Planning Statement

Montague Quarter – Adjustment to overall height of development – Rev B

This statement sets out the design evolution and reasoning behind the need to increase the overall height of the proposed development from the approved planning consent.

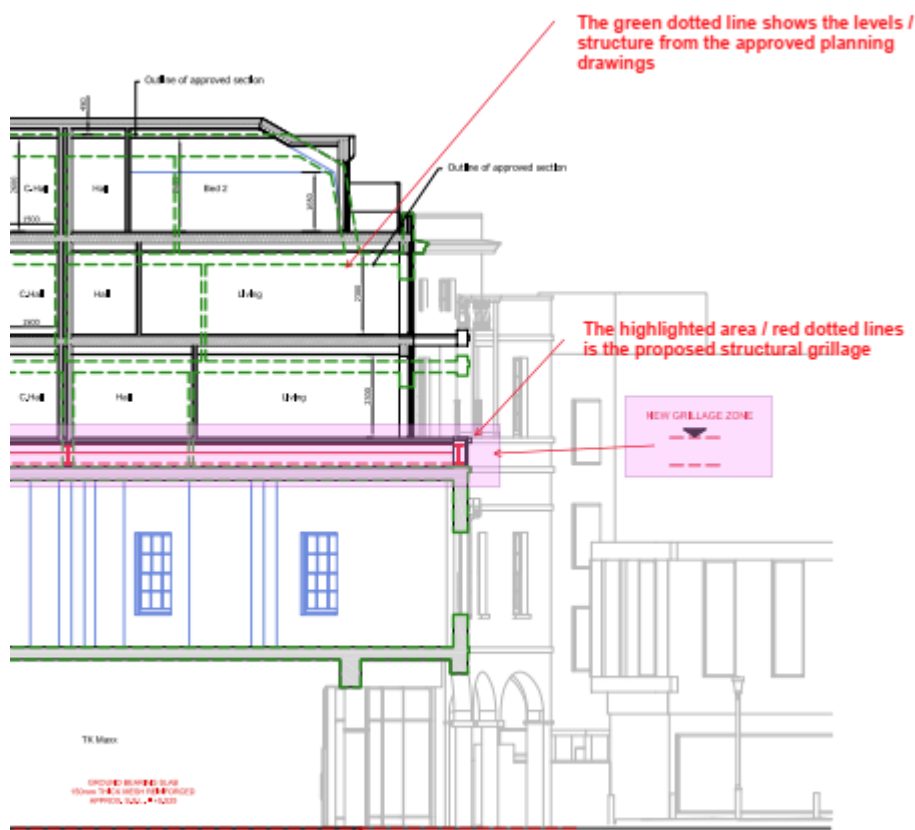
- Zone A will only have an additional 1 level above existing structure and poses no issues with the existing structure.
- Zone B and C will have 3 additional floors and therefore substantially increase loadings onto the existing structure.

To overcome the issue of the loadings in Zones B & C a steel grillage will need to be installed (Zone B at 1st floor and Zone C at 2nd floor). The depth of the steel grillage will need to be 865mm to be able to spread the load onto existing columns. The grillage will allow the vertical loadings to transfer from the new structure above through the grillage directly to the top of the existing structural columns. Unfortunately, it is impossible for the new structure to line through with the existing structure below, hence the need for the structural grillage.

The above section through the proposed building shows the line of the structural grillage at 2nd floor level (Zone C) above TK Maxx. The green dotted line shows the levels / structure from the approved planning drawings.

Rather than just increase Zone B and C roof lines by 865mm, we have looked at how we can adjust the floor to ceiling heights to accommodate the height increase. However, we needed to respect the elevational treatment / proportions of the approved drawings, i.e. keep the difference in height of the 1st floor and the configuration of the window heights etc (1st floor 2.7m floor to ceiling, mid floors 2.3m and top floors 2.6m due to the sloped ceilings).

By making the internal adjustments above, we have been able to reduce the overall height impact to a minimum, with Zone B increasing by 505mm and Zone C by 446mm see blow.
